## Addendum to IFB

**IFB NUMBER:** IFB 22-028/JW

**IFB TITLE:** Rehabilitation of Fuel Farm Pavement at the Jack Brooks Regional

**ADDENDUM NO.:** 2

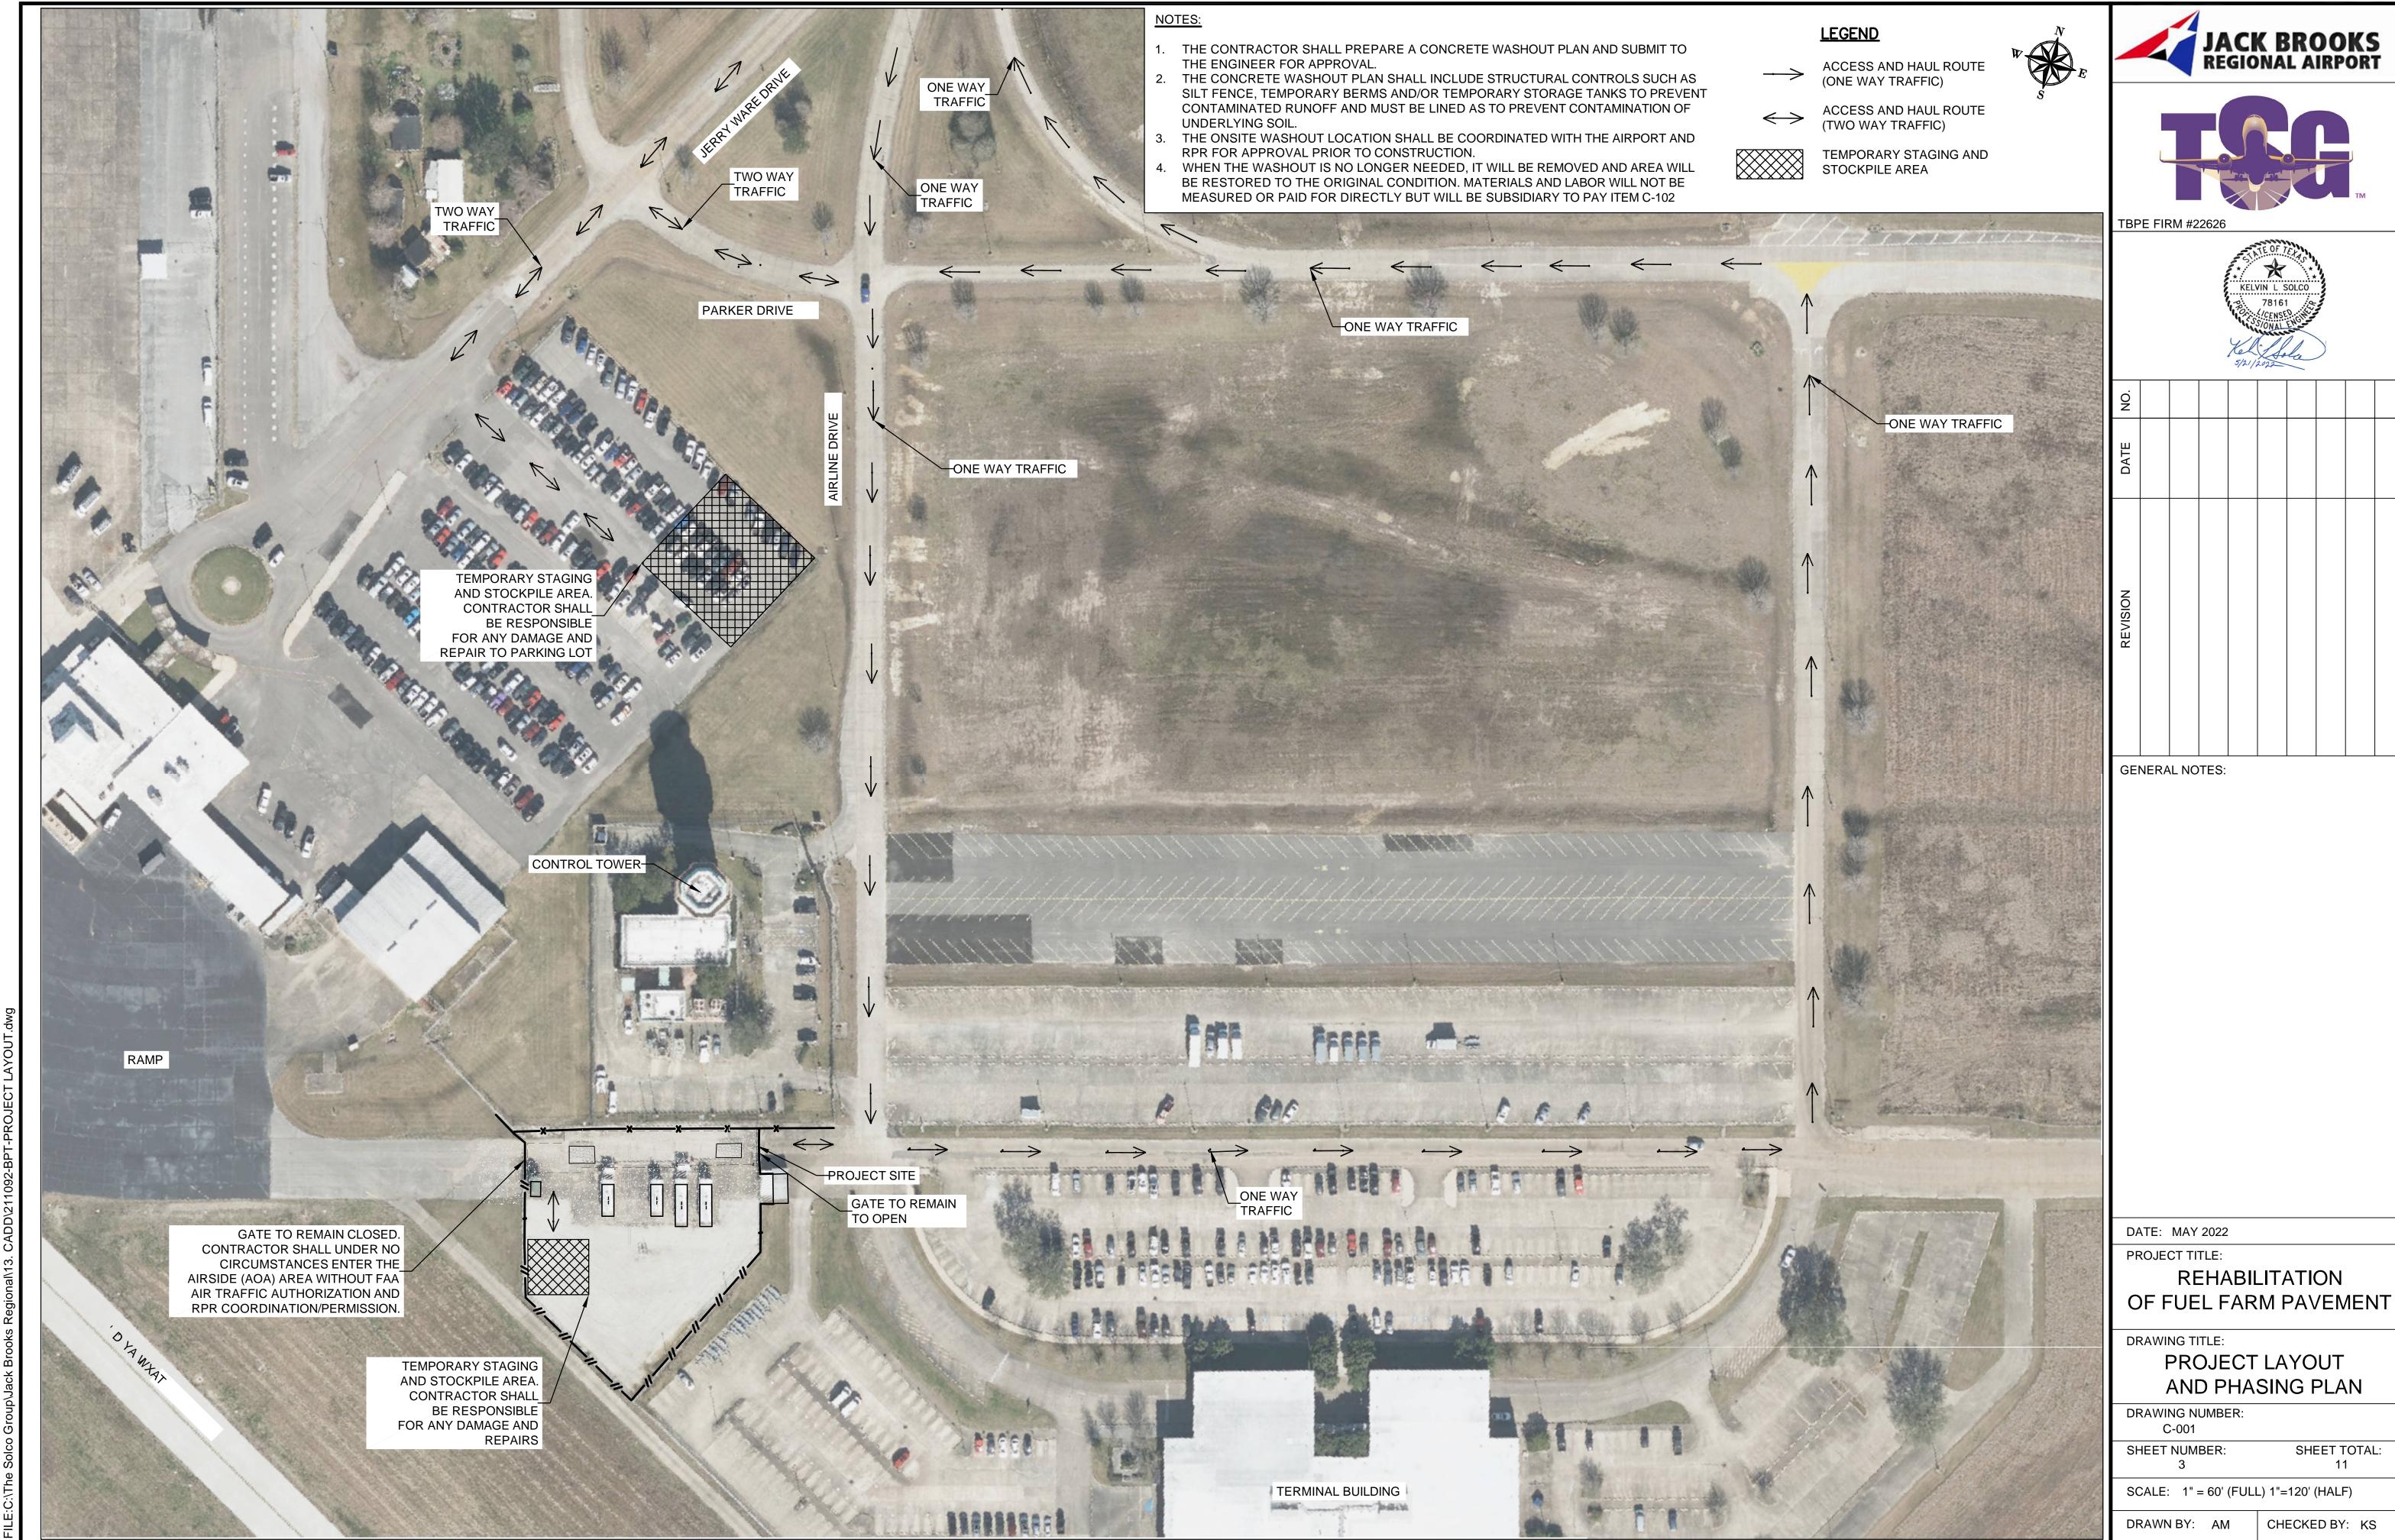
- 1. Who is responsible for Materials Testing? All quality assurance testing shall be done by the Contractor. Please see the Items below:
  - a. Item 152-5, section 152-2.10 under paragraph 2, last sentence.
  - b. Item 155-4, section 155-6.10 and a. Density Paragraph
  - c. Item 501-7, section 501-3.3 f., 501-3.4 Concrete Mix Submittal, 501-4.8 c.
     Consolidation, 501-4-11 e. Straightedge testing and surface correction., P-501-24
     CONTRACTOR QUALITY CONTROL (CQC)
  - d. Page 8 of 61 of bid documents section 2.12.
- 2. DRAWING PLAN SHEET 3 Replace Sheet 3 with New Sheet 3. Arrow for "One-Way" traffic corrected.
- 3. BID DOCUMENTS Replace pg. 42 with New Page to include TOTAL BID LINE.
